SUBJECT: *Comments on Draft Consequence Study, NRC-2013-013*

Declaration of 1 August 2013
by Gordon R. Thompson:

Comments on the US Nuclear Regulatory Commission's
Draft Consequence Study of a Beyond-Design-Basis
Earthquake Affecting the Spent Fuel Pool
for a US Mark I Boiling Water Reactor

Figure VII-1
One of the Pool Layouts Modeled in NRC's Draft Consequence Study: The OCP2, High-Density, 1x4 Case

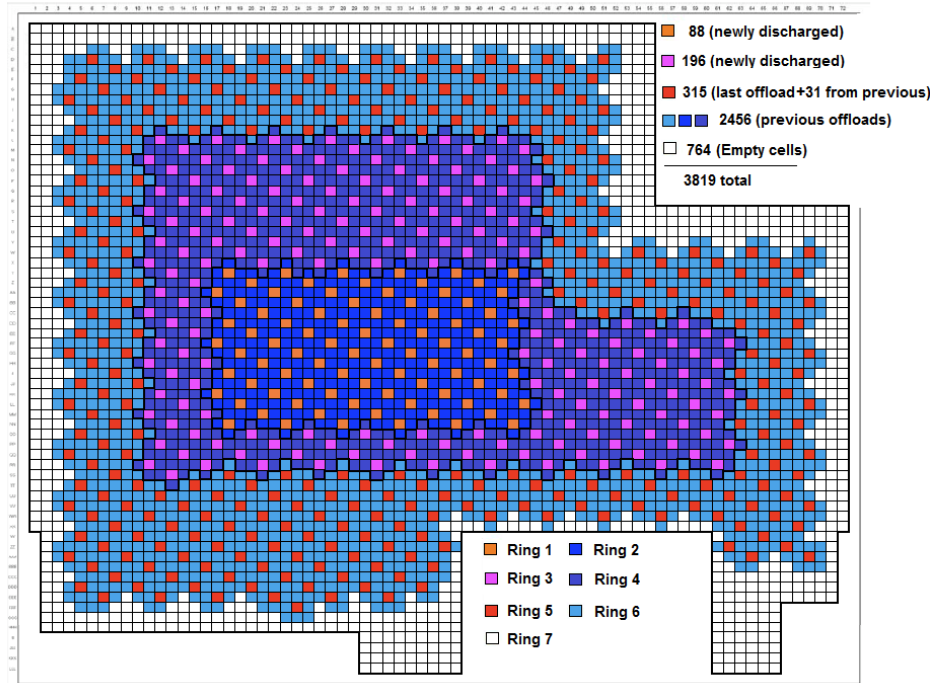
(VII-5) In addition to questions about the validity of MELCOR, there are questions about NRC's input assumptions. For example, how closely does the pool layout shown in Figure VII-1 correspond with actual practice in the nuclear industry? In that context, there is a puzzling NRC assumption associated with Figure VII-1. That figure shows a total of 284 newly-discharged fuel assemblies. Of these, 88 assemblies are assumed by NRC to produce decay heat at the rate of 10.9 kW per assembly when aged 20 days, while the remaining 196 assemblies produce 6.6 kW per assembly at the same age.⁴⁷ If this is typical practice, then licensees are forgoing substantial available burnup of the

majority of their fuel assemblies, with a resulting economic penalty.⁴⁸ As a related matter, Figure VII-1 shows a rather elaborate layout of fuel, whose achievement would involve substantial shuffling of assemblies. NRC says that this layout is comparatively favorable in terms of the risk of a pool fire. Yet, licensees are allowed a period of time, during and perhaps after a refueling outage, to perform the shuffling needed to achieve a favorable layout. The length of that period of time is a secret because, NRC says, this information could be useful to an adversary.⁴⁹ Thus, is it appropriate to assume, as a MELCOR input, that a comparatively favorable layout has been achieved before water is lost?

Figure VII-2
Findings from NRC's Draft Consequence Study: Water Level and Ring 1 Cladding Temperature for Unmitigated High-Density Moderate Leak (OCP4)

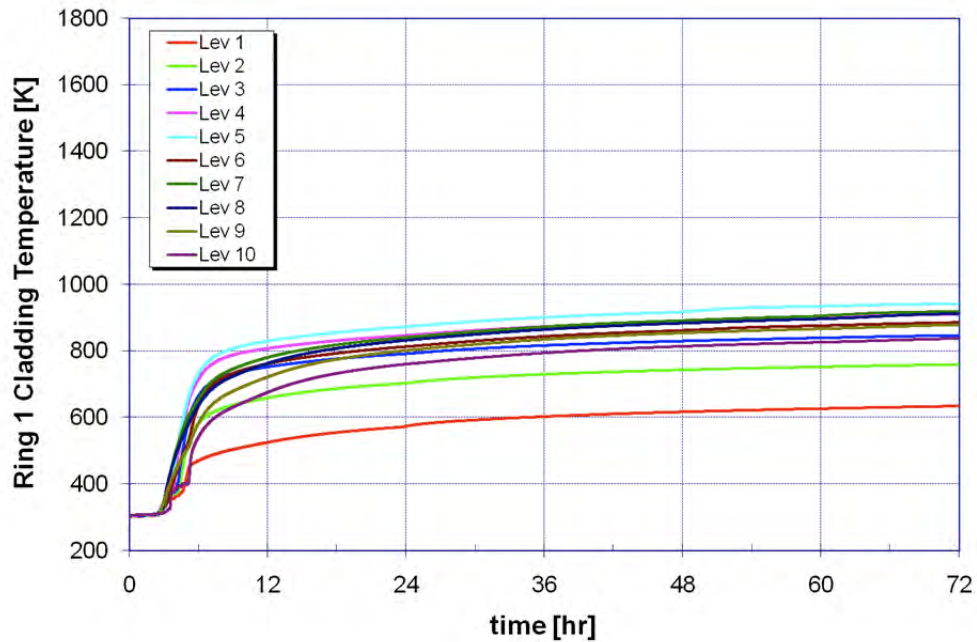
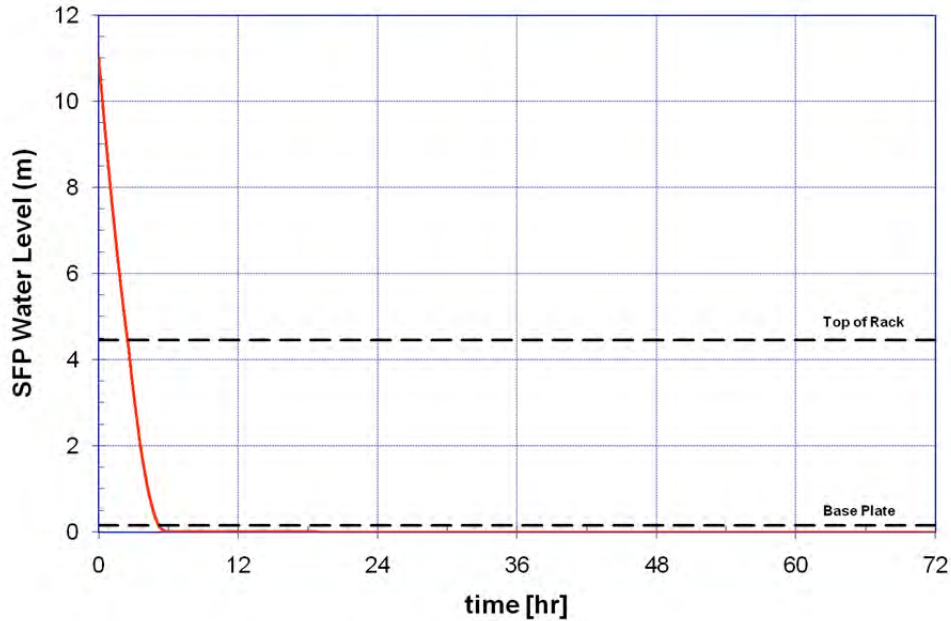
(VI-11) These illustrative calculations show that a pool fire could occur if water loss occurred during a particular operating cycle phase – OCP4. NRC's Draft Consequence Study finds (see Figures VII-2 and VII-3) that a pool fire would not occur in OCP4 with the same pool loading. That finding reflects NRC's decision to focus its analysis exclusively on water-loss scenarios involving total drainage of water from a pool. By adopting that focus, NRC has ignored a substantial part of the pool-fire risk.

(VII-10) Now, consider MELCOR outputs for NRC's examination of a moderate-leakage case in OCP4, as shown in Figure VII-2. During the evolution of this case, there would be a period of time when the upper portion of the fuel is exposed and residual water is present. That period would extend from about $t = 3$ hours to about $t = 6$ hours. During that 3-hour period, at the "Lev 5" elevation of the fuel, cladding temperature would rise from about 300 K to about 700 K. Thus, the average rate of temperature rise would be about 130 K per hour. This finding indicates that the exposed portion of the fuel at the Lev 5 elevation would be in an approximately adiabatic situation, at least for temperatures up to 700 K.

Figure VII-3
Findings from NRC's Draft Consequence Study: Water Level and Ring 1 Cladding Temperature for Unmitigated High-Density Small Leak (OCP4)

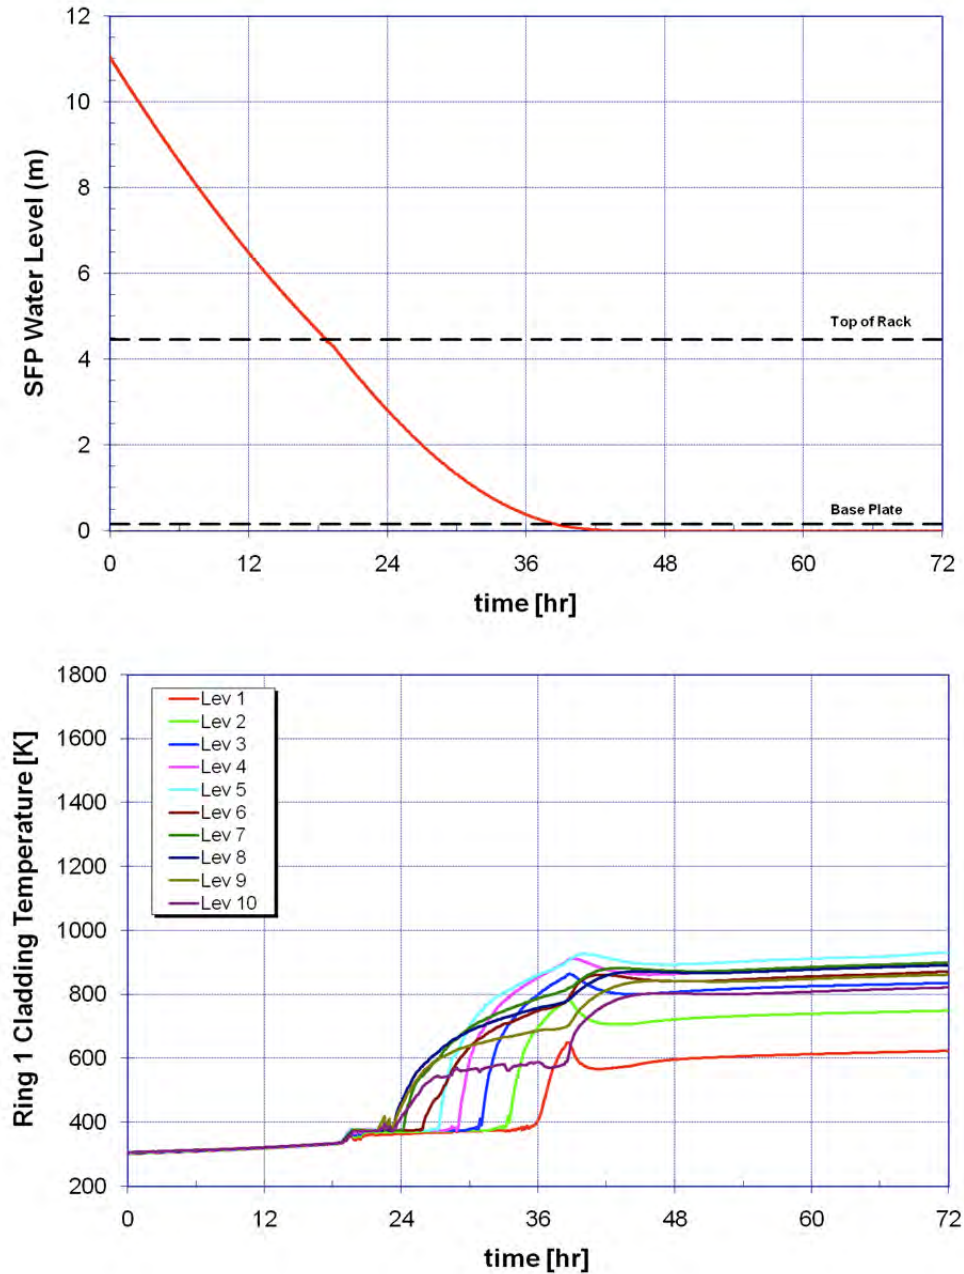
(VII-11) Now, apply the same process, as in the preceding paragraph, to NRC's examination of a small-leakage case as shown in Figure VII-3. In that case, the period of time when fuel at the Lev 5 elevation is exposed and residual water is present would extend from about $t = 28$ hours to about $t = 40$ hours. During that 12-hour period, the temperature of fuel cladding at the Lev 5 elevation would rise from about 350 K to about 900 K. Thus, the average rate of temperature rise would be about 46 K per hour.
